Access Compliance Report

Public Rights-of-Way

(Pedestrian Signals)

Intersection ID: N/A	Main Street:	Cross Street: N/A	Location: N/A
ADA ID: B3B575FCECAD	Signal Type: One Push Button-Non APS	Overall Compliance: No	Severity Score: BTN 1: N/A BTN 2: N/A No BTN: N/A
Codes/Mitigation Info/Possible Solution		Field Measurements/Component Compliance

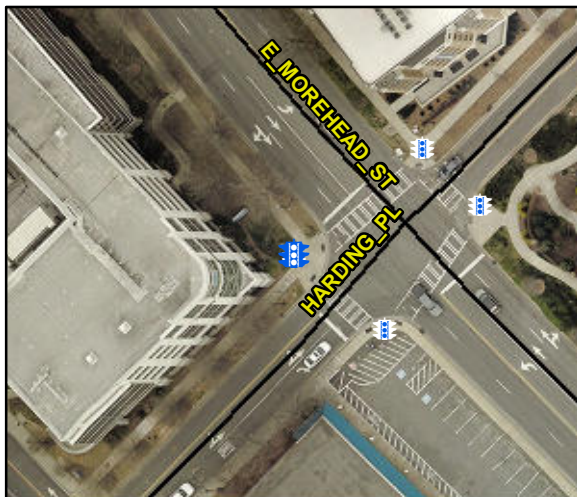
Compliance	Description	Data	Compliance	Description	Data
	Button Count	Button1	N/A	Distant to Additional Button (in)	N/A
	Additional Button Present?	No		Additional Button ID	N/A
N/A	Signal Buttons Required?	N/A	N/A	Additional Ped Posts Required	N/A
	How Many Ped Street Xings?	2		Located In An Island/Median?	No
N/A	B 1 Sign Present?	Yes	N/A	B 2 Sign Present?	N/A
Yes	B 1 Sign Purpose?	Yes	N/A	B 2 Sign Purpose?	N/A
Yes	B 1 Sign Lettering & Contrast?	Yes	N/A	B 2 Sign Lettering & Contrast?	N/A
Yes	B 1 Parallel To XWalk?	Yes	N/A	B 2 Parallel To XWalk?	N/A
Yes	B 1 PAR to Button?	Yes	N/A	B 2 PAR to Button?	N/A
Yes	B 1 PAR to XWalk?	Yes	N/A	B 2 PAR to XWalk?	N/A
Yes	B 1 Clear Floor Space?	Yes	N/A	B 2 Clear Floor Space?	N/A
N/A	B 1 FWD Approach?	Yes	N/A	B 2 FWD Approach?	N/A
N/A	B 1 FWD Approach Constrained?	No	N/A	B 2 FWD Approach Constrained?	N/A
No	B 1 FWD Approach Reach (in)	9.0	N/A	B 2 FWD Approach Reach (in)	N/A

N/A	B 1 FWD Approach Width (in)	N/A	N/A	B 2 FWD Approach Width (in)	N/A
N/A	B 1 FWD Approach Obstruction?	Yes	N/A	B 2 FWD Approach Obstruction?	N/A
N/A	B 1 FWD Approach Obstruction Dist (in)	3.0	N/A	B 2 FWD Approach ObstructionDist (in)	N/A
N/A	B 1 PARA Approach?	Yes	N/A	B 2 PARA Approach?	N/A
N/A	B 1 PARA Approach Constrained?	No	N/A	B 2 PARA Approach Constrained?	N/A
Yes	B 1 PARA Approach Reach (in)	9.0	N/A	B 2 PARA Approach Reach (in)	N/A
N/A	B 1 PARA Approach Width (in)	N/A	N/A	B 2 PARA Approach Width (in)	N/A
N/A	B 1 PARA Approach Obstruction?	Yes	N/A	B 2 PARA Approach Obstruction?	N/A
N/A	B 1 PARA Approach Obstruction Dist (in)	3.0	N/A	B 2 PARA Approach ObstructionDist (in)	N/A
No	B 1 Clear Floor Space Slope (%)	4.5	N/A	B 2 Clear Floor Space Slope (%)	N/A
Yes	B 1 Clear Floor Space XSlope (%)	2.0	N/A	B 2 Clear Floor Space XSlope (%)	N/A
N/A	B 1 PAR Slope (%)	0.4	N/A	B 2 PAR Slope (%)	N/A
Yes	B 1 Height (in)	37.0	N/A	B 2 Height (in)	N/A

Yes	B 1 Pressure (#)	2.0	N/A	B 2 Pressure (#)	N/A
No	B 1 Closed Fist Operation?	No	N/A	B 2 Closed Fist Operation?	N/A

Yes	B 1 Clear Xing Direction?	ClearlyMarked	N/A	B 2 Clear Xing Direction?	N/A
	B 1 Crossing Direction	To NE		B 2 Crossing Direction	N/A
Yes	B 1 DistanceTo XWalk (in)	22.0	N/A	B 2 DistanceTo XWalk (in)	N/A
No	B 1 DistanceTo Curb (in)	186.0	N/A	B 2 DistanceTo Curb (in)	N/A
Yes	B 1 Diameter (in)	2.0	N/A	B 2 Diameter (in)	N/A

Possible Solutions: Replace Signal Push Button With APS Button on New Post. Remove & Relocate Sign.
